**Additions and Renovations  
Platt Technical High School  
Milford, CT**

**ADDENDUM NO. 2**

July 29, 2019

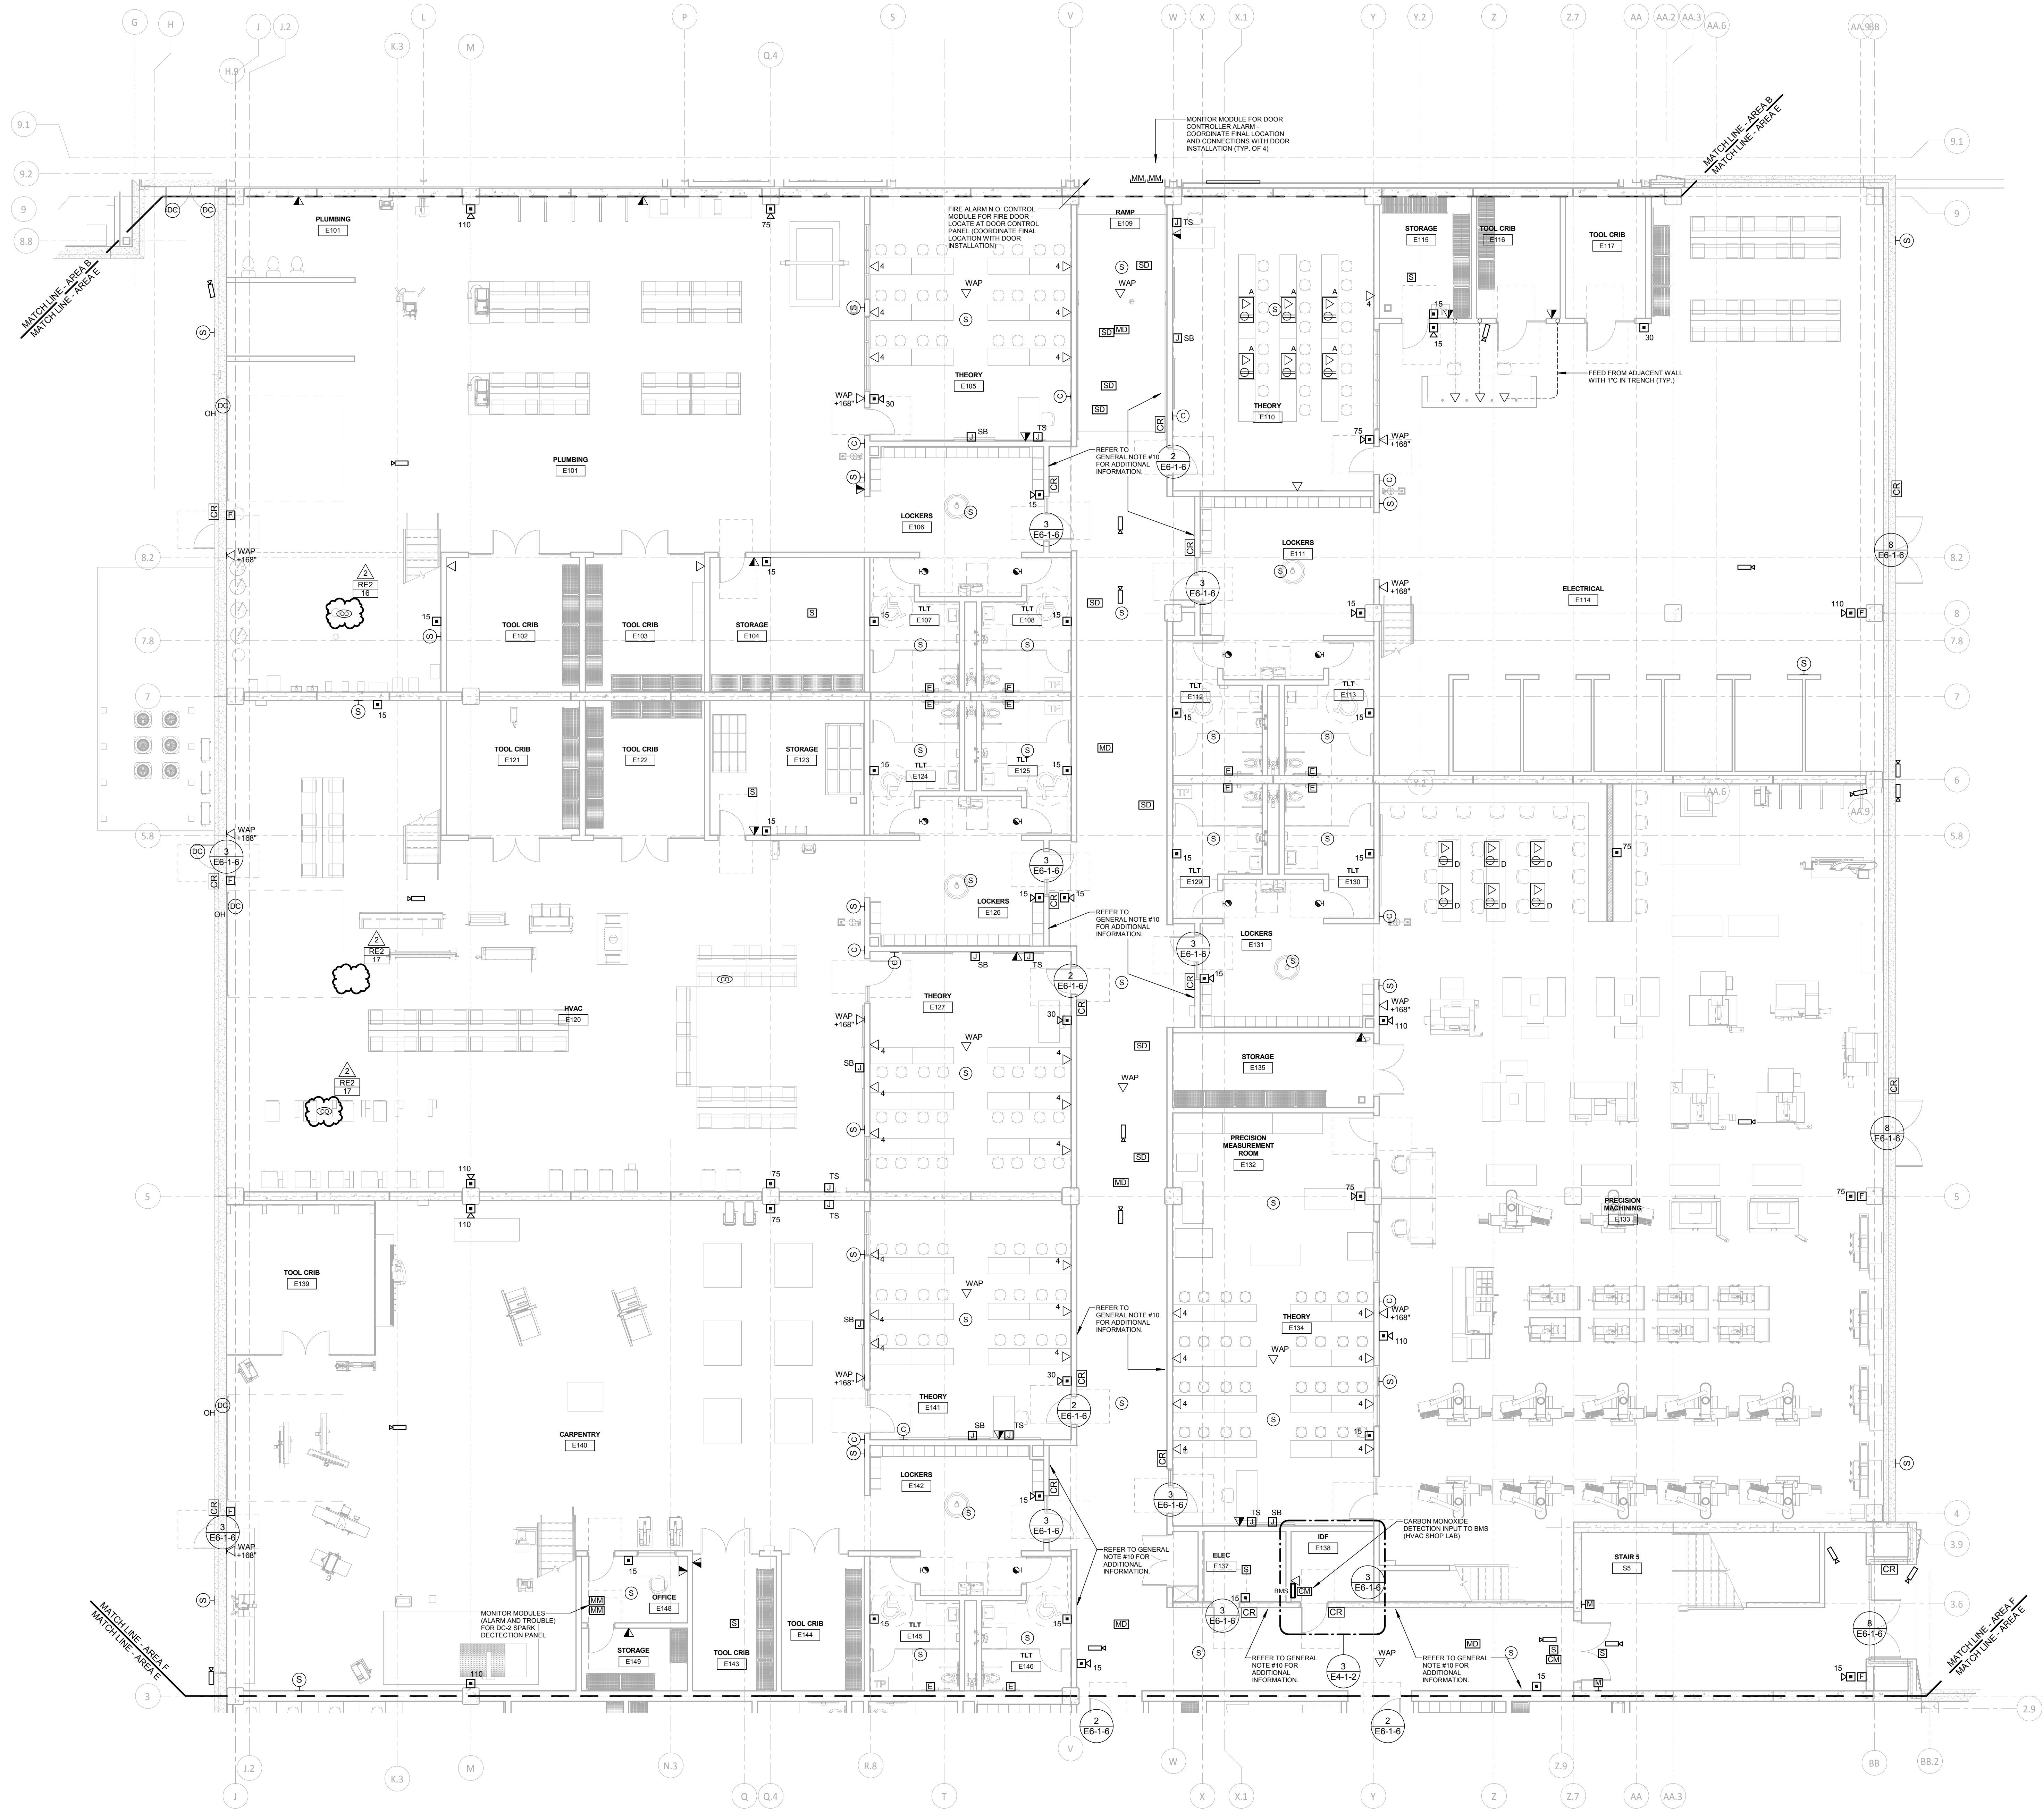
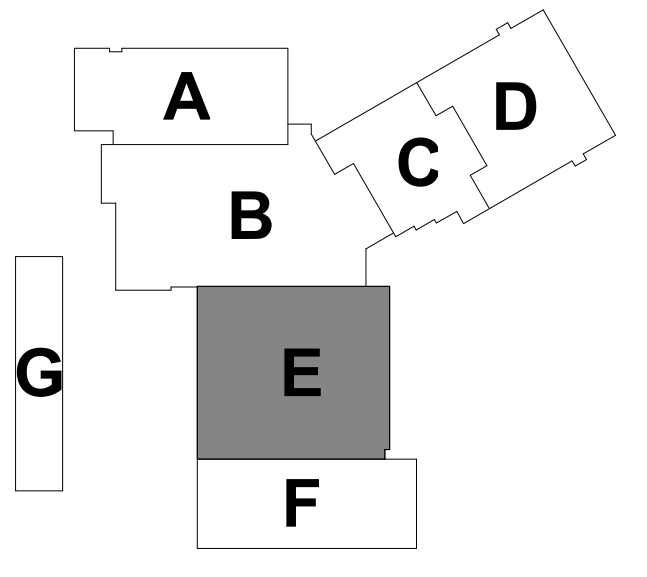
- ADD 2-048      DRAWING E3-1-1E – FIRST FLOOR ELECTRICAL SYSTEMS PLAN AREA E**  
Added CO detector to be within range for gas equipment in Plumbing E101 per Revision RE2-16.  
Relocated CO detector to be within range for gas equipment in HVAC E120 per Revision RE2-17.

1 SECOND FLOOR ELECTRICAL SYSTEMS PLAN AREA E  
1/8" = 1'-0"

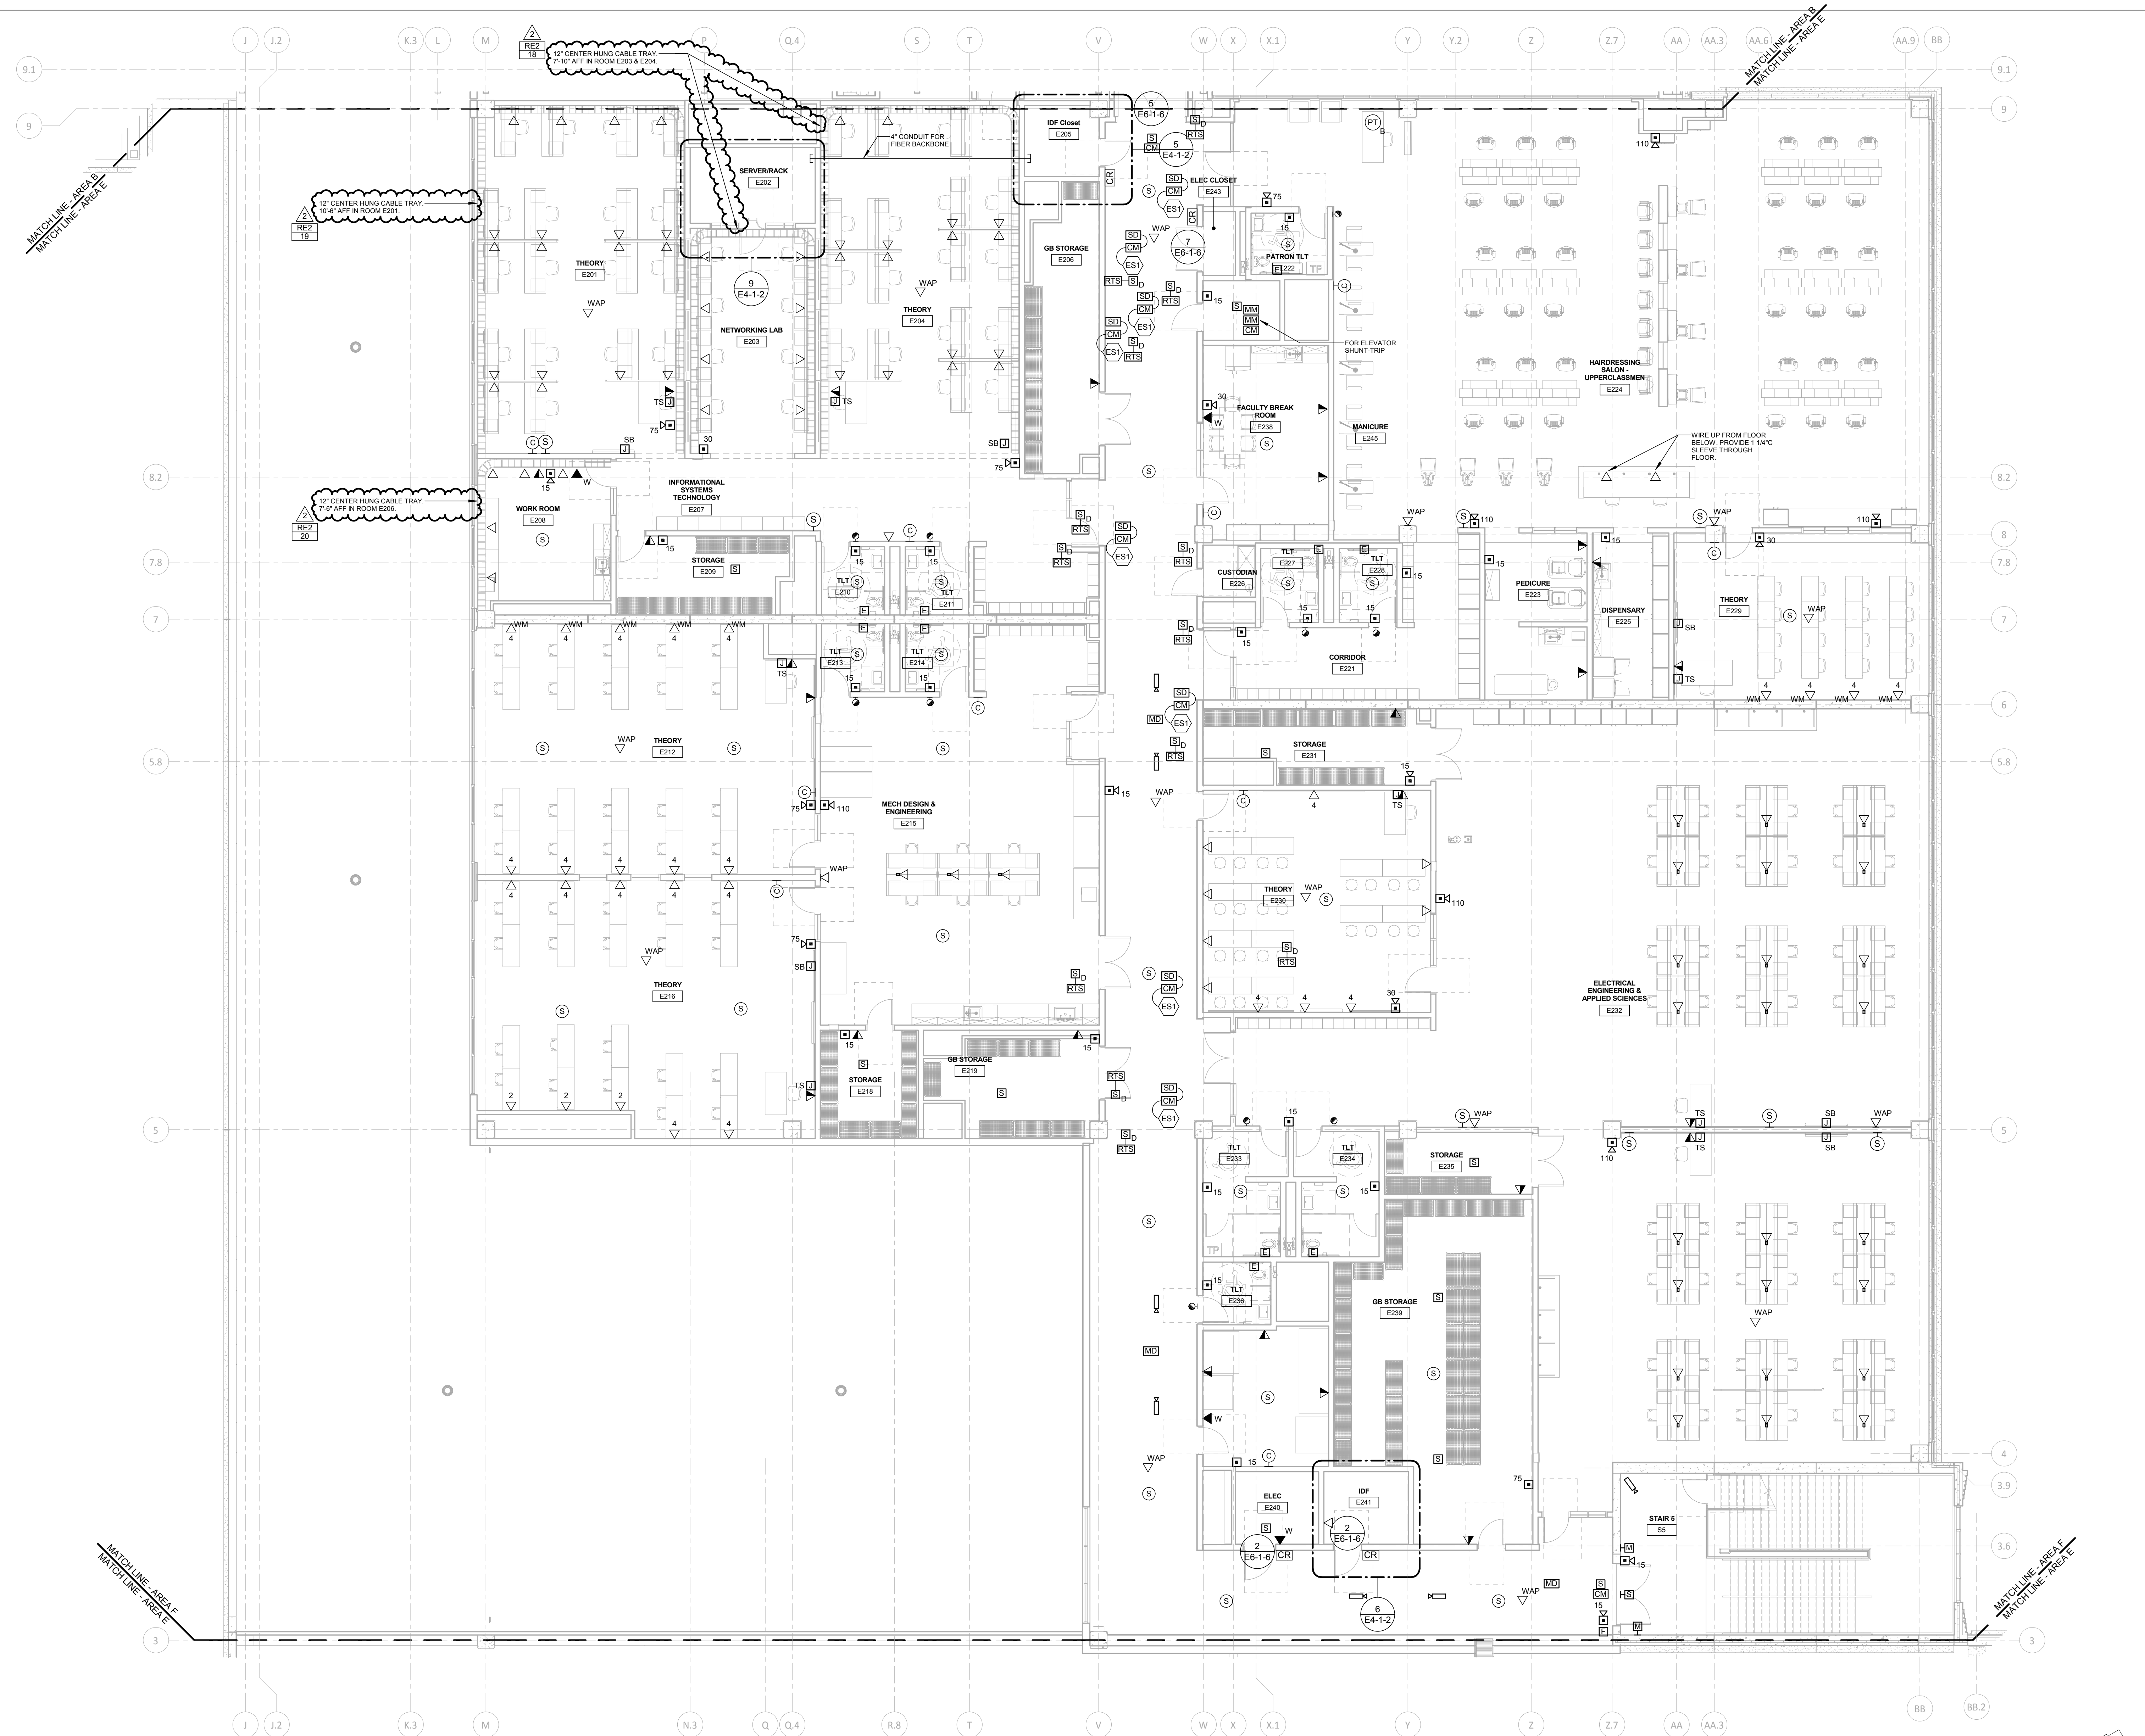
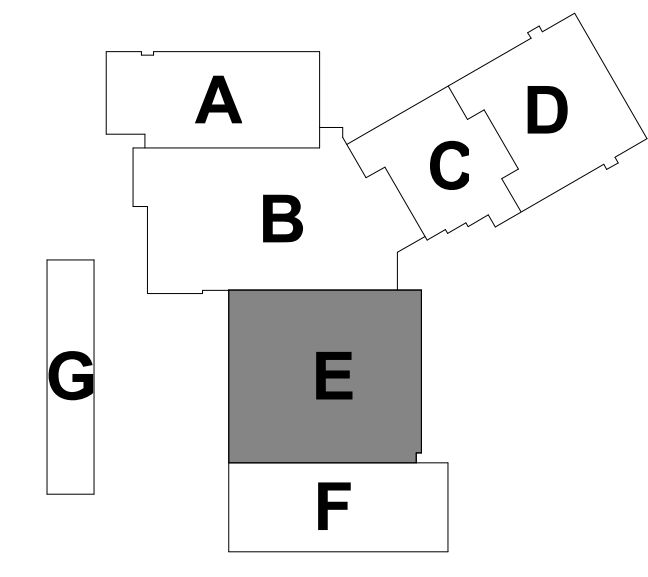
- ADD 2-049      DRAWING E3-1-2E – SECOND FLOOR ELECTRICAL SYSTEMS PLAN AREA E**  
Added callout for cable tray size and mounting heights for Networking Lab E203 and Theory E204 per Revision RE2-18.  
Added callout for cable tray size and mounting heights for Theory E201 per Revision RE2-19.  
Added callout for cable tray size and mounting heights for Work Room E206 per Revision RE2-20.
